MFN 07-425

Subject: **Response to Portion of NRC Request for Additional Information  
Letter No. 70 – Related to ESBWR Design Certification Application –  
RAI Number 14.2-44**

**RAI Number 14.2-44**

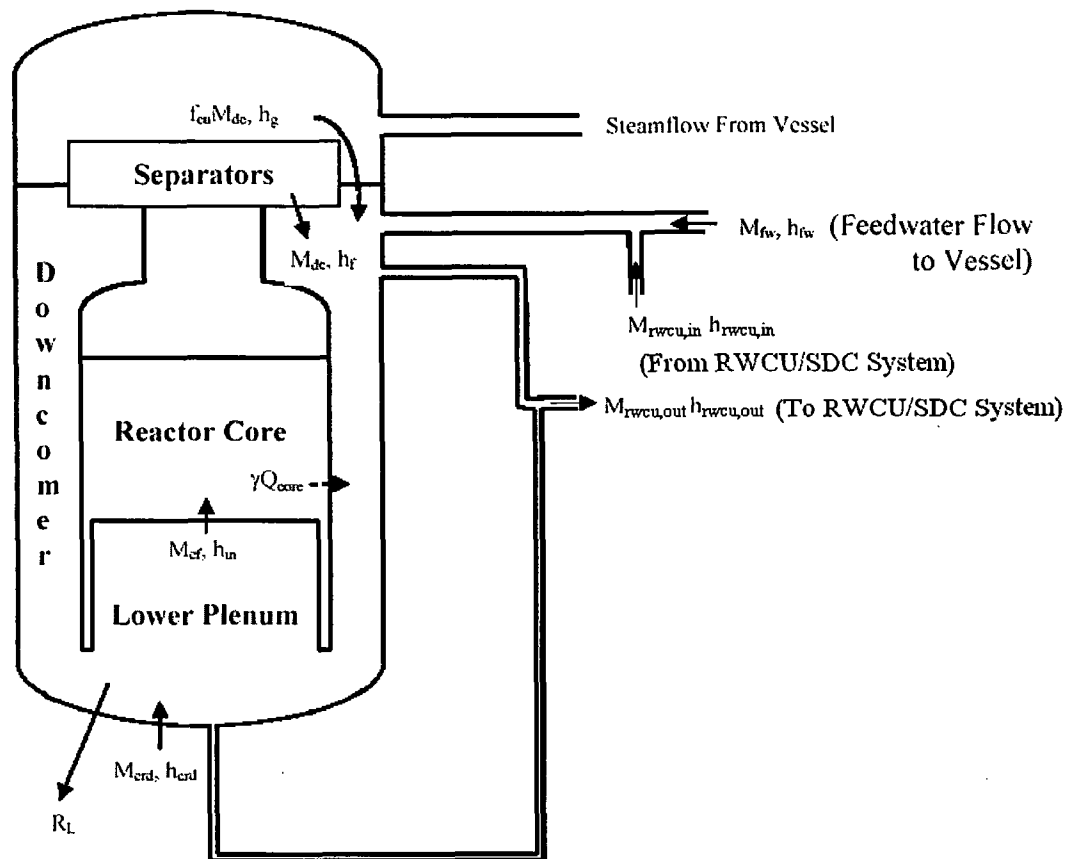
*Please provide specific methods on how you will calculate core flows and core power. What variables will be obtained from the in-vessel measurement to calculate core flows and core power? Please provide a detailed test plan for testing vessel natural circulation at various power levels after fuel loading during startup testing.*

Under normal operation condition, a control volume (CV) is established or defined as the liquid volume of the downcomer region and lower plenum region as shown in the following schematic figure. In the figure, key flow paths are identified to keep track of the mass and energy across the boundaries (entering or leaving) the CV. The basic idea of heat balance method is to use the steady-state conservation of mass and energy equations for the CV to derive an equation for the core flow.

The following equation can be obtained from mass conservation of CV

$$M_{cf} + M_{rwc, out} = M_{dc}(1+f_{cu}) + M_{fw} + M_{rwc, in} + M_{crd} \quad (1)$$

Conservation of CV energy gives a second equation

$$M_{cf}h_{in} + M_{rwcui,out}h_{rwcui,out} + R_L = \gamma Q_{core} + M_{dc}(h_f + f_{cu}h_g) + M_{fw}h_{fw} + M_{rwcui,in}h_{rwcui,in} + M_{crd}h_{crd} \quad (2)$$

Thus, equations (1) and (2) form a linear system in terms of unknowns  $M_{cf}$  and  $M_{dc}$ , where the remaining terms in equations (1) and (2) can be either measured or evaluated based on measurement. Therefore,  $M_{cf}$  can be solved by eliminating  $M_{dc}$  and the solution can be summarized in a single equation as a function of all the following terms
